CALL NO. 200
CONTRACT ID NO.
131212 Addendum # 2

Subject: Marshall Trigg County, 121GR13D012 - NHPP 0801 (098)
Letting December 20, 2013

- (1) Revised - Plan Sheets - R2, S2, S134, S183, S184A, S184B, S187, S192, S194, S206, S207, S207A, S207B, S208, S208A, S208B, S209, S209A, S210, S211, S212, S213, S216, S217, S260, S261, S274
- (2) Revised - Cover Page - PAGE 1 of 403
- (3) Revised - Completion Dates - Page 4 of 403
- (4) Revised - Multiple Notes - Various Pages
- (5) Revised - Bid Items - Page 397-403 of 403
- (6) Delete - Pages 27thru44, 216thru233, 207thru215, 234thru238 of 403

PLAN OF SLAB

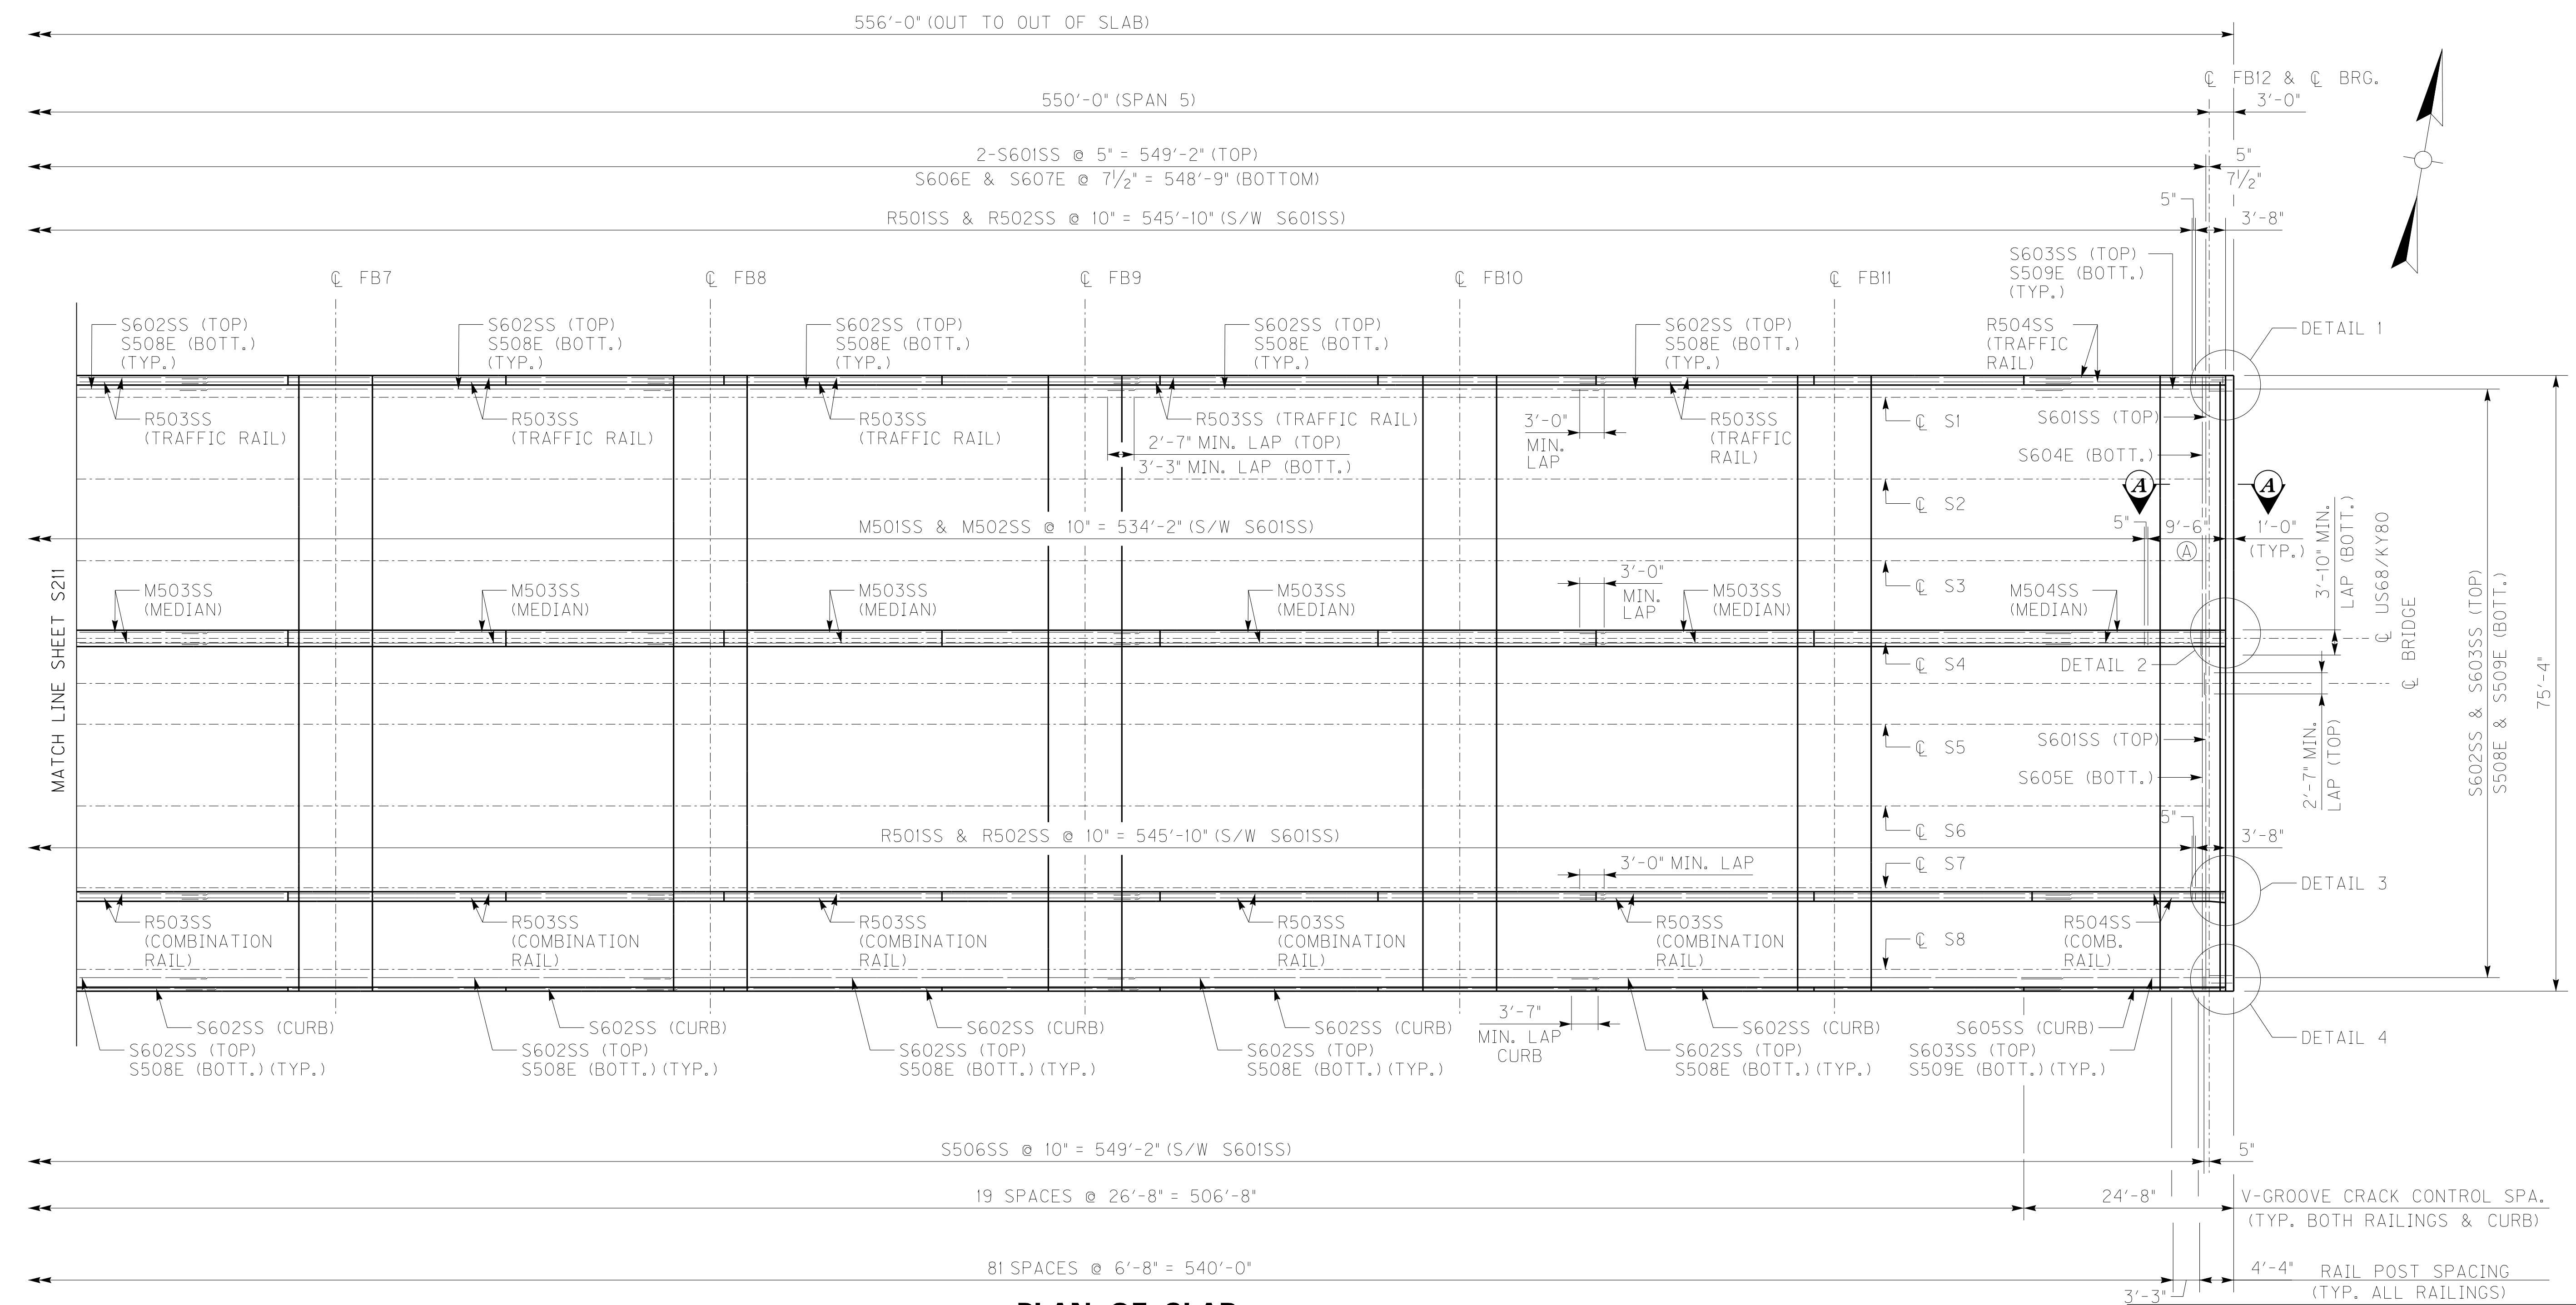
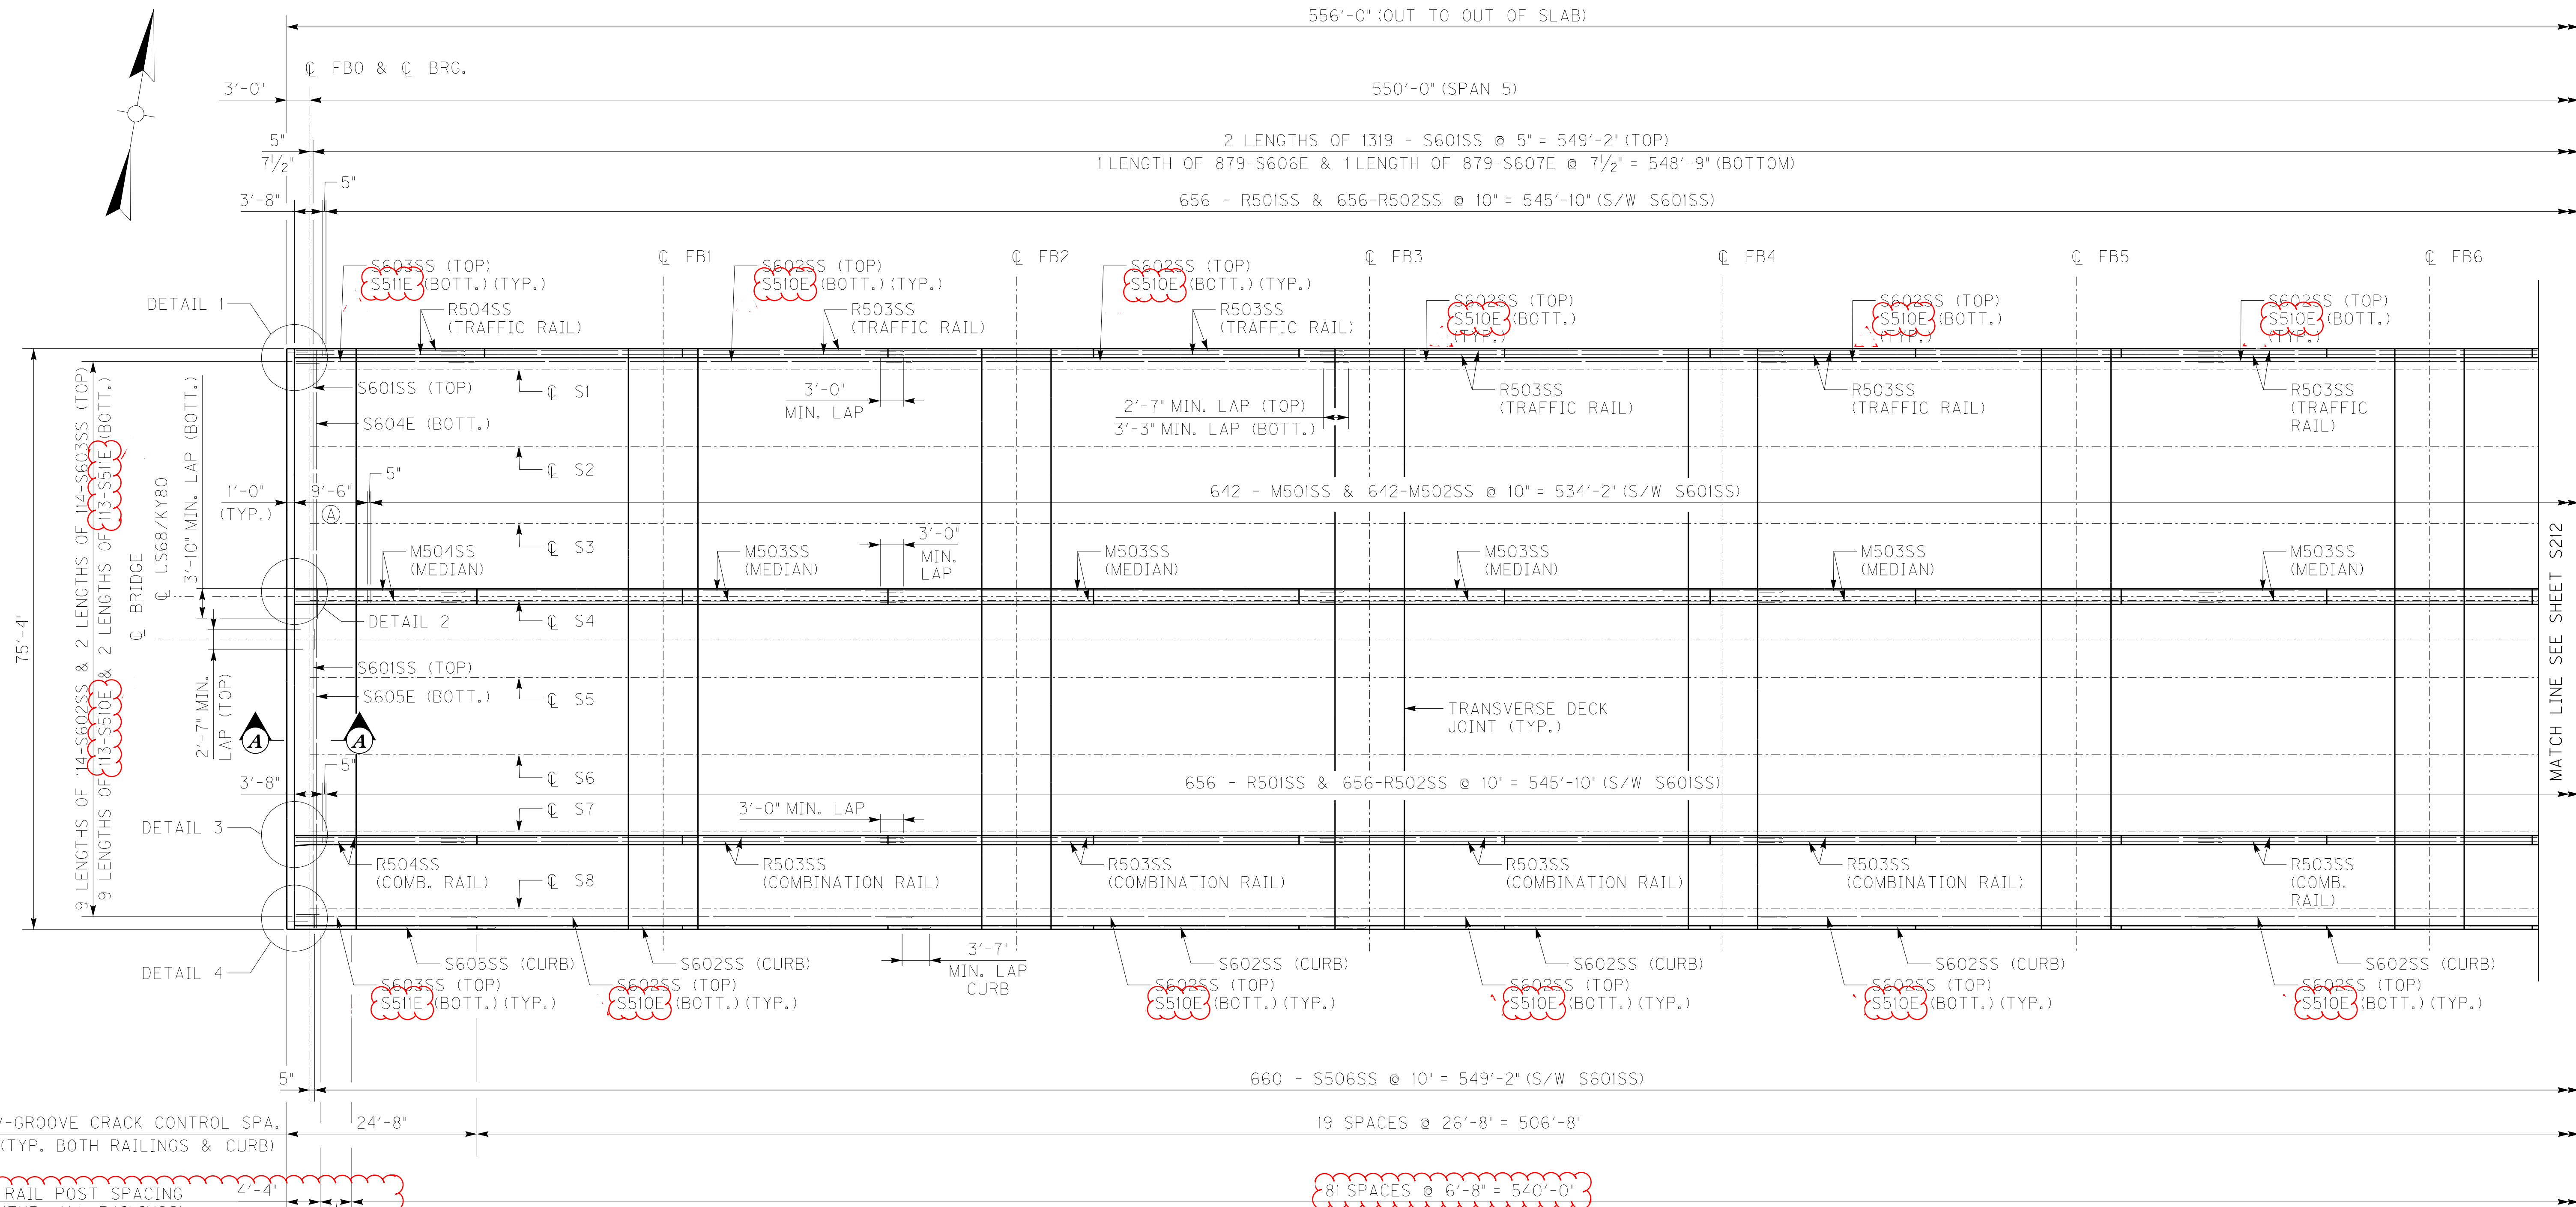
REVISED POST SPACING & DETAIL 4 REVISION DATE: NOVEMBER 15, 2013 DESIGNED BY: ACK DETAILED BY: MJD		CHECKED BY LEV ACK DATE: 11/25/13
Commonwealth of Kentucky DEPARTMENT OF HIGHWAYS COUNTY MARSHALL / TRIGG		
ROUTE US68	CROSSING KENTUCKY LAKE	
PLAN OF SLAB PREPARED BY Baker		
SHEET NO. S212 DRAWING NO. 24686		SHEET NO. S212 DRAWING NO. 24686
